**Proposed development: Prior Approval - Solar Panels Non-domestic Buildings for Installation of Solar Photo Voltaic (SPV) arrays to roof areas as highlighted within the supporting documentation as part of the Public Sector Decarbonisation Scheme (PSDS)**

**Site address:  
Pleasington Cemetery & Crematorium  
Tower Road  
Blackburn  
BB2 5LE**

**Applicant: Blackburn With Darwen Borough Council**

Figure 3: Proposed Elevations

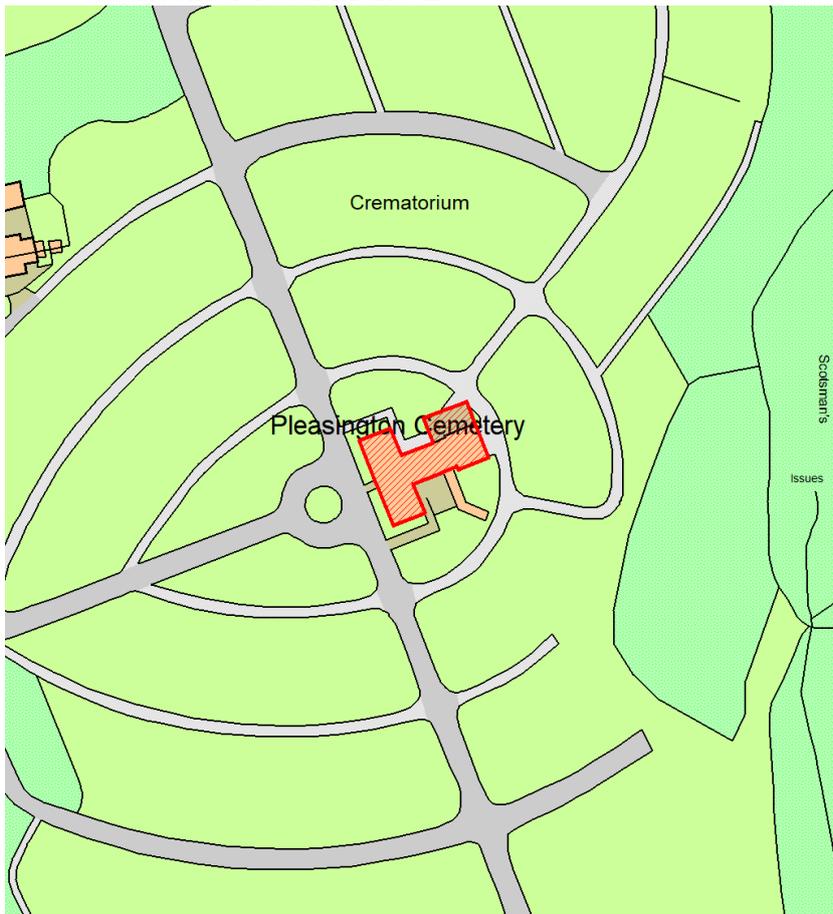
- 3.5.30 The host building features a flat roof aspect to the front with a parapet wall around the perimeter. As such, the solar panels which are to be positioned on the flat roof will subsequently not be able to be viewed from public vantage points given screening from the surrounding parapet wall. For these reasons, it is considered that the proposal would not be harmful to the visual amenities of the host building or its setting.

- 3.5.31 In relation to impact on glare on occupiers of neighbouring land, the proposal site is within an isolated location, and thus away from nearby buildings. Also, due to the siting of the solar panels on a flat roof it is not considered such glare impacts would arise.

- 3.5.32 Additionally, solar panels are designed to absorb a high level of light, and use of dark materials mitigates much of the glare impact. As such, the proposal is considered to be acceptable from an amenity perspective, in line with the requirements of Policy 8 of the Local Plan Part 2 (2015).
